Access Compliance Report

Public Rights-of-Way

Intersection ID: 16133	Main Street: E_W_T_HARRIS_BV	Cross Street: IDLEWILD_RD_NORTH	Location: SW
ADA ID: 8AC4E7956FF1	Ramp Type: Perp	Initial Pass/Fail: Fail	Overall Compliance: No
Severity Score: 48.75			
Codes/Mitigation Info/Possible Solution		Field Measurements/Component Compliance

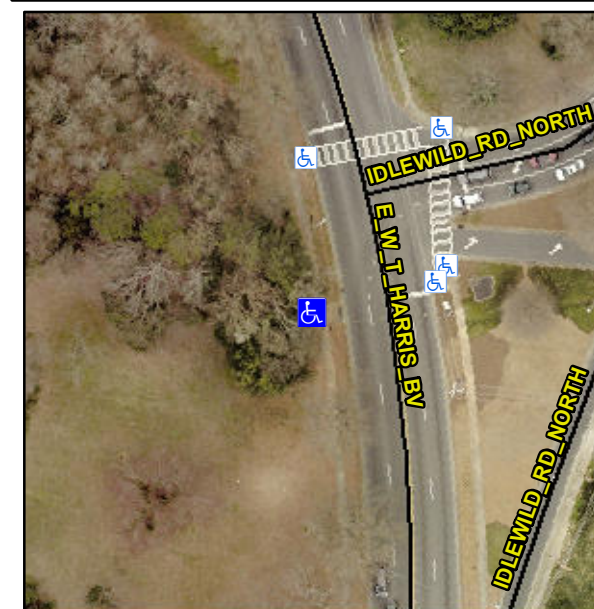
Not Found, R304.5.1, R304.2.2, R304.5.3

Compliance	Description	Data	Compliance	Description	Data
N/A	Ramp Length (in)	63.0	No	Ramp Slope (%)	9.4
No	Ramp Width (in)	30.0	No	Ramp XSlope (%)	3.0
N/A	Flare Type LT	N/A	N/A	Flare Type RT	N/A
N/A	Flare Slope LT (%)	N/A	N/A	Flare Slope RT (%)	N/A
N/A	Flare Traversable LT?	N/A	N/A	Flare Traversable RT?	N/A
N/A	Landing Length (in)	N/A	N/A	DWS Provided?	N/A
N/A	Landing Width (in)	N/A	N/A	DWS Contrast?	N/A
N/A	Landing Slope (%)	N/A	N/A	DWS Length (in)	N/A
N/A	Landing X Slope (%)	N/A	N/A	DWS Full Width?	N/A
N/A	Landing Curb? (Y/N)	N/A	N/A	DWS Offset (in)	N/A
N/A	Shared Landing?	N/A			
N/A	Gutter Ponding?	N/A	N/A	Gutter Slope (%)	N/A
N/A	Gutter Lip Ht (in)	N/A	N/A	Gutter X Slope (%)	N/A
N/A	Painted X Walk1?	No	N/A	Painted X Walk2?	N/A
	X Walk 1 Direction	To E		X Walk 2 Direction	N/A
N/A	X Walk 1 Width (in)	N/A	N/A	X Walk 2 Width (in)	N/A
	X Walk 1 Slope (%)	2.4		X Walk 2 Slope (%)	N/A
	X Walk 1 X Slope (%)	2.4		X Walk 2 X Slope (%)	N/A

Remove & Replace Entire Ramp.
